RU-513, jam code 75-42 or 75-43

ID: KBA00039440

Field mod to RU-513 to Correct Jamming on Long Continuous Runs

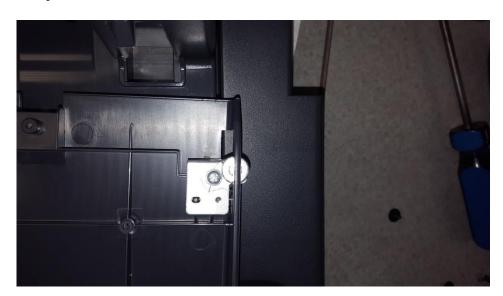
- 1. Disassemble the RU-513, separating the top cover from the base, by removing the rear hinge pin.
- 2. Separate the lid bottom from the top.
- 3. Remove the paper entry side hinge bracket from the lid (top cover) of the RU-513. This is the hinge closest to the fuser. Install a small washer under the bracket so that the screw passes through it.
